ADDENDUM NO. 2

PROJECT: ITB PW 65-20 SOUTHWEST CRESTVIEW BYPASS (PHASE V AND EAST-WEST CONNECTOR)

August 28, 2020

OKALOOSA COUNTY

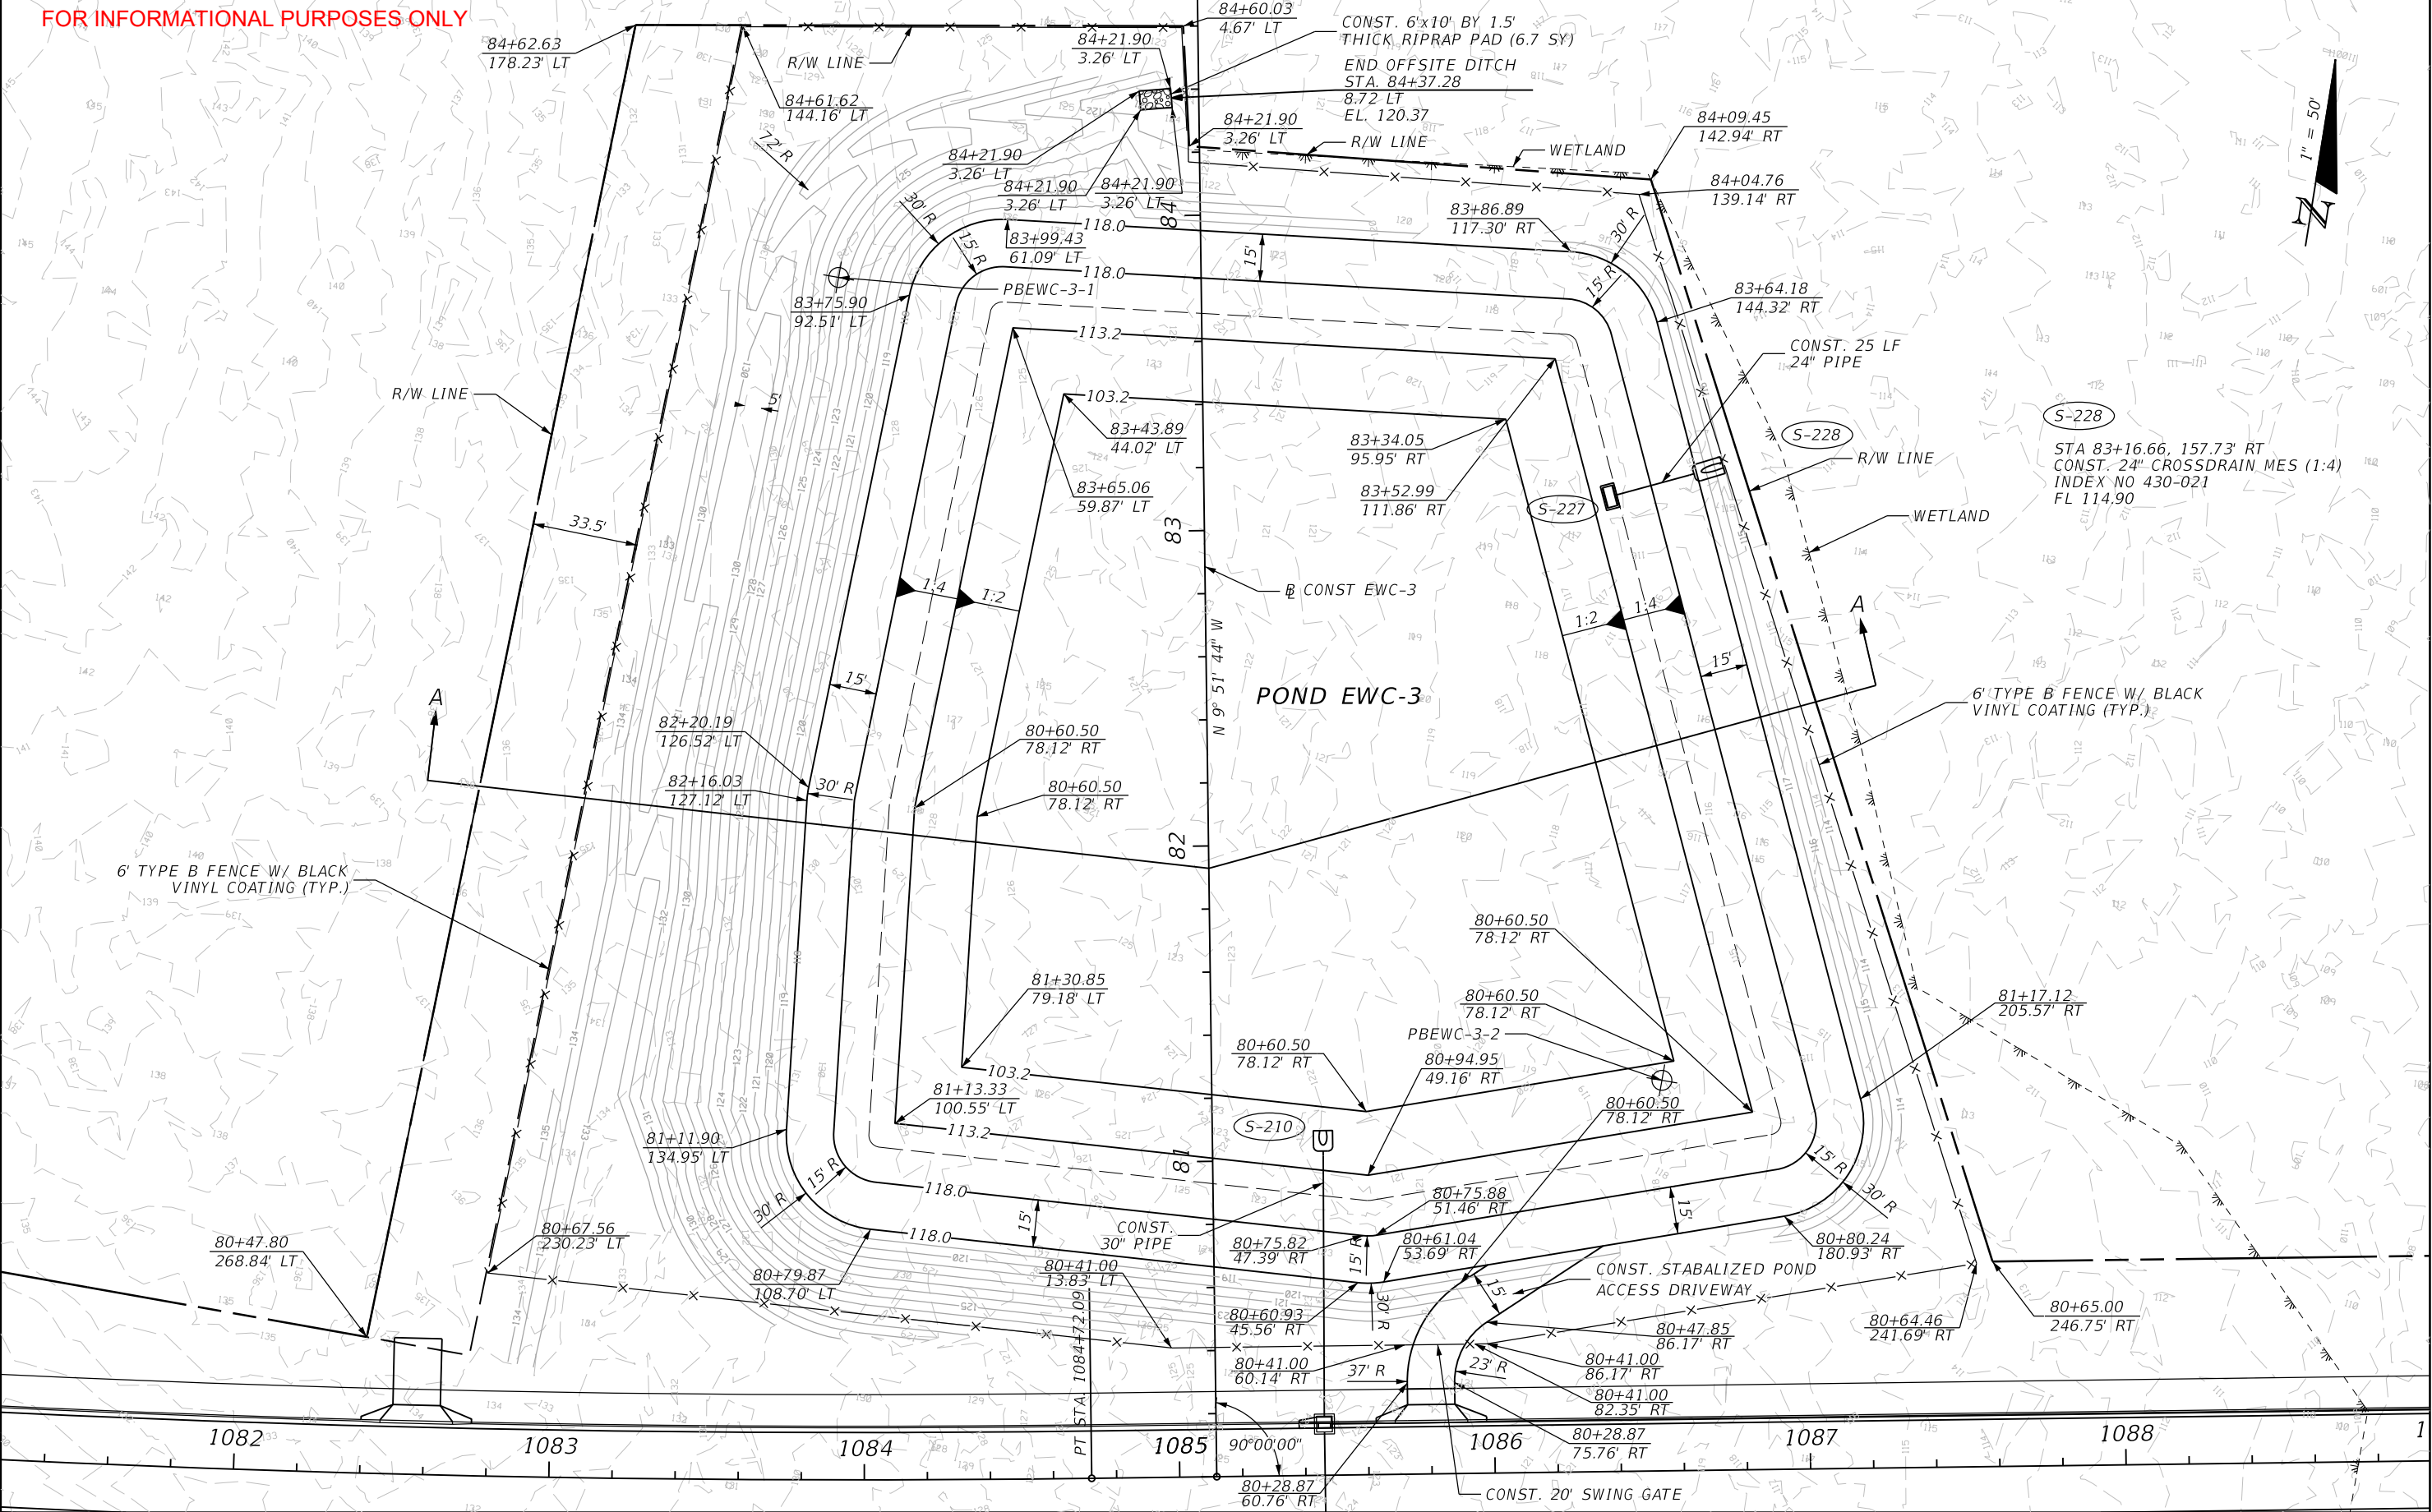
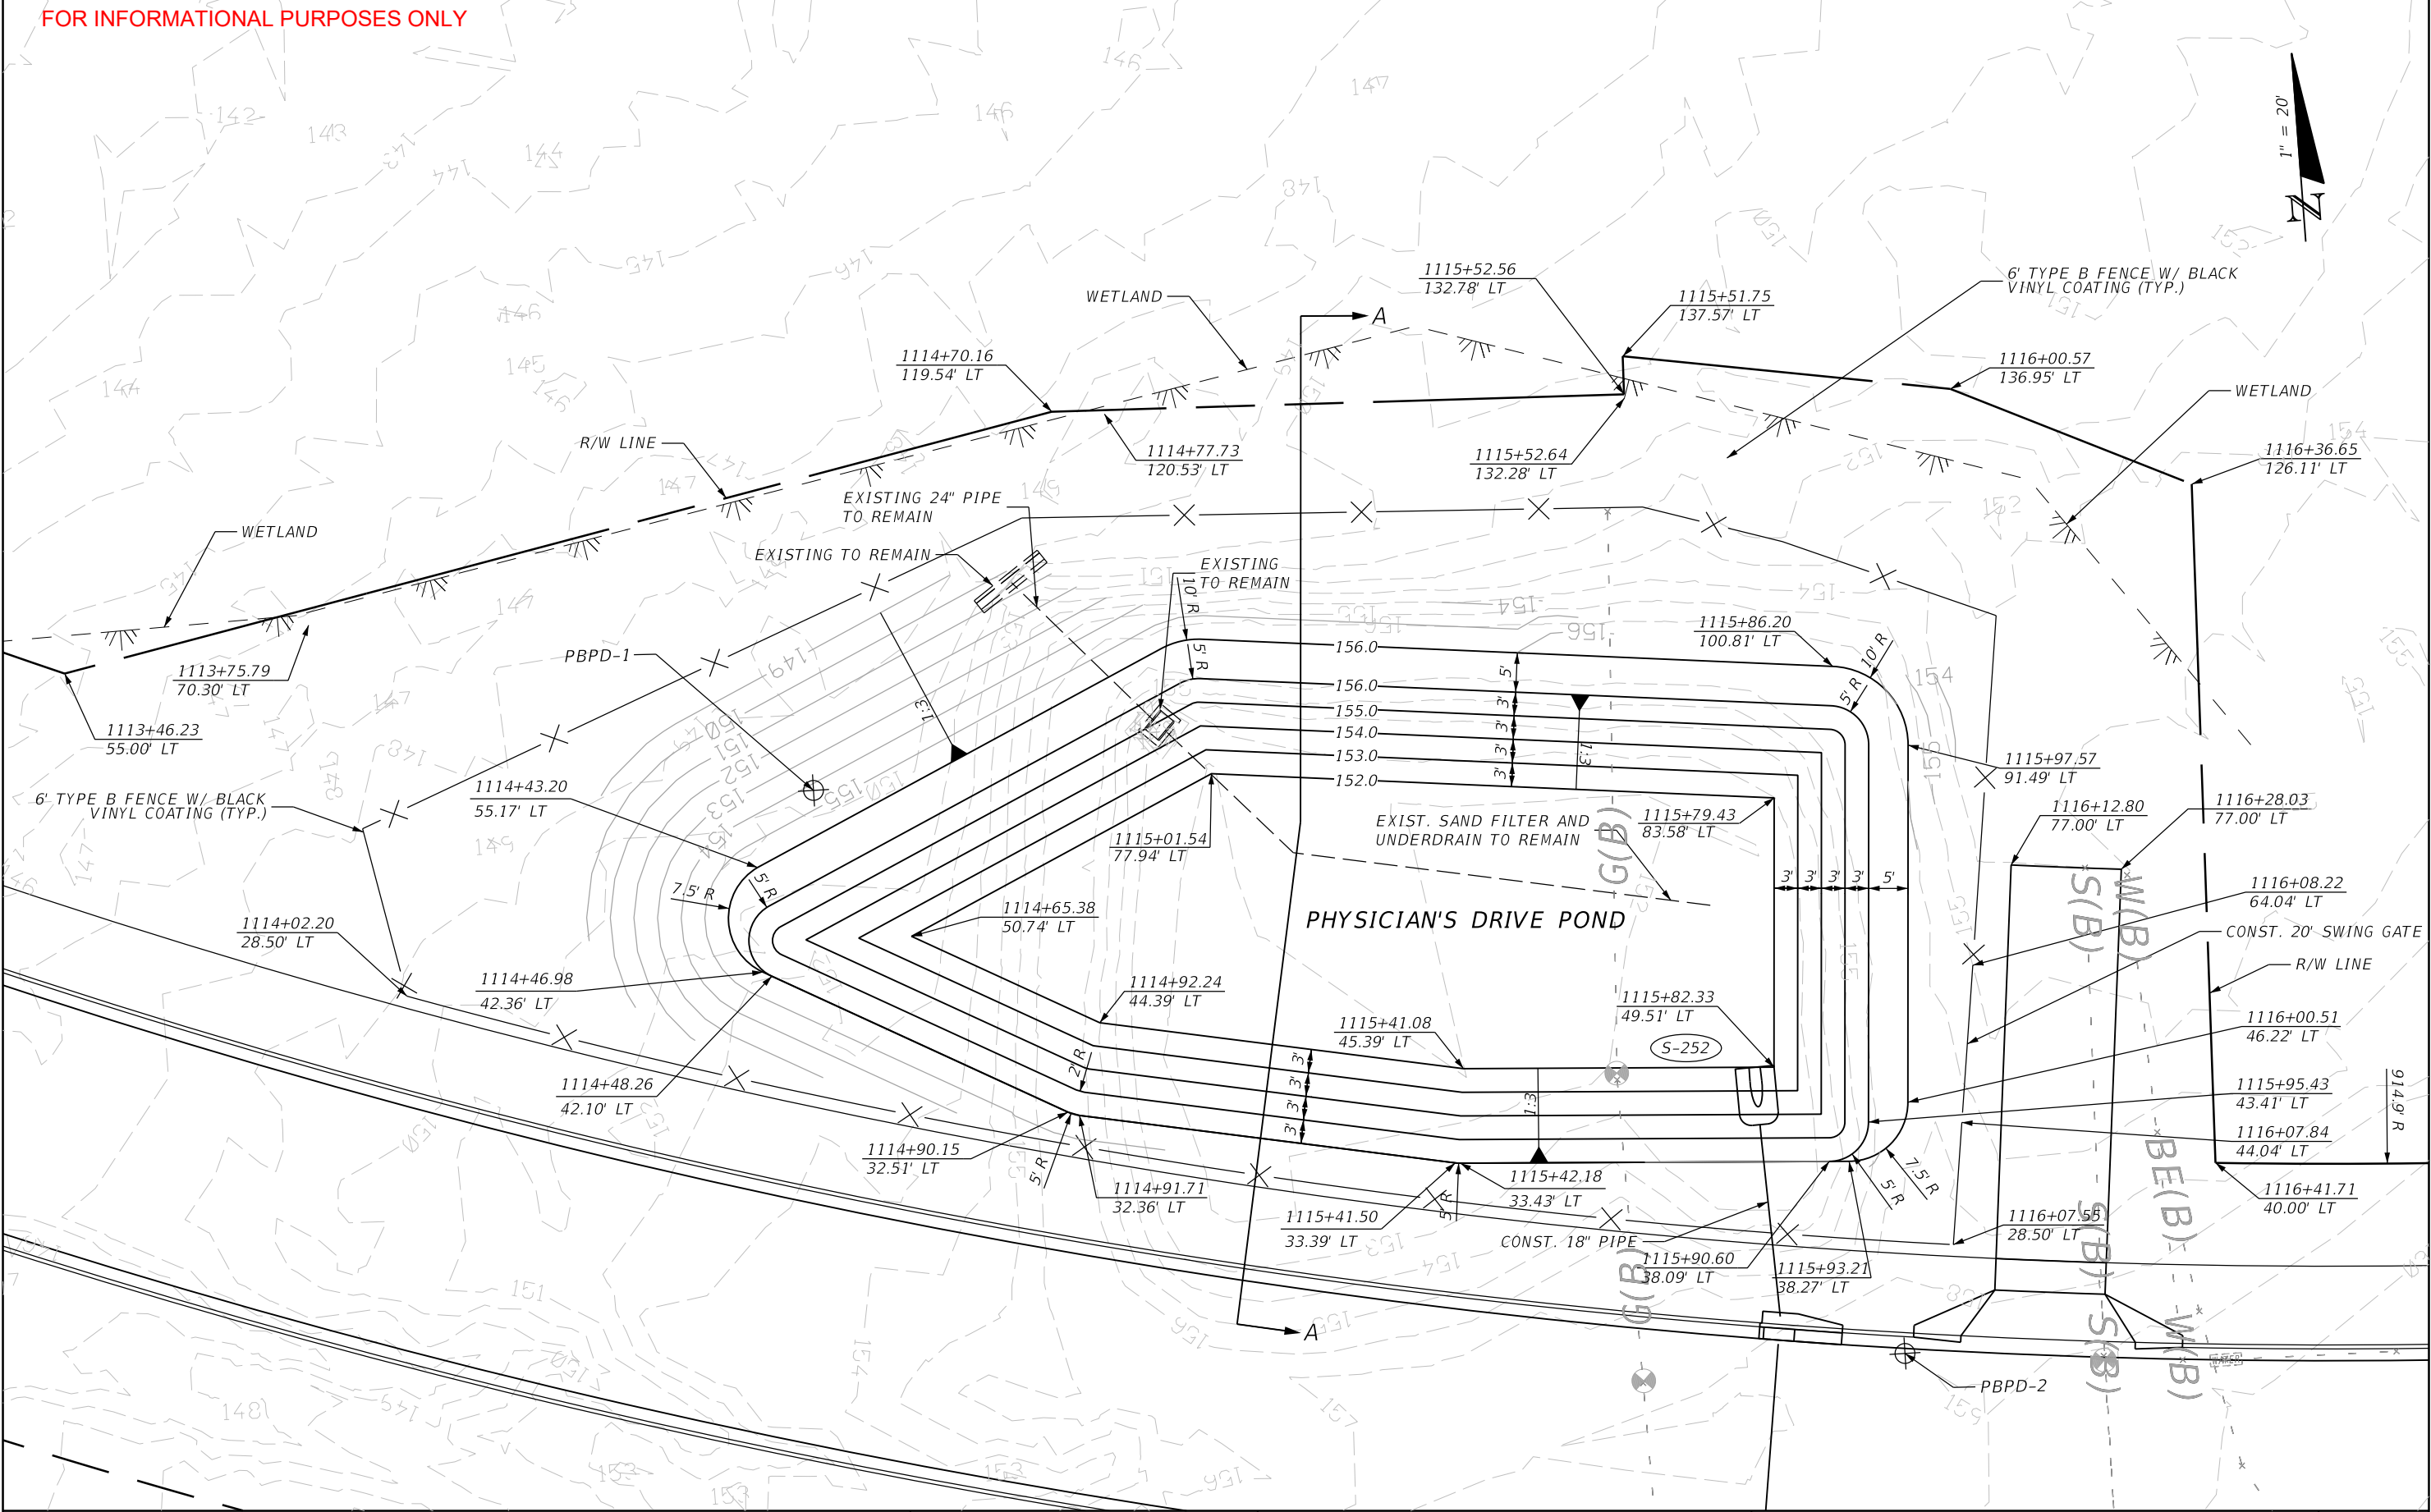
Question 4: *“Can pond plan sheets (102-111 E-W Connector) be provided that contain existing contour lines?”*

Answer 4: Copies of pond plan sheets 102-111, E-W Connector that depict the existing contour lines are attached to this Addendum. The sheets are marked For Information Only.
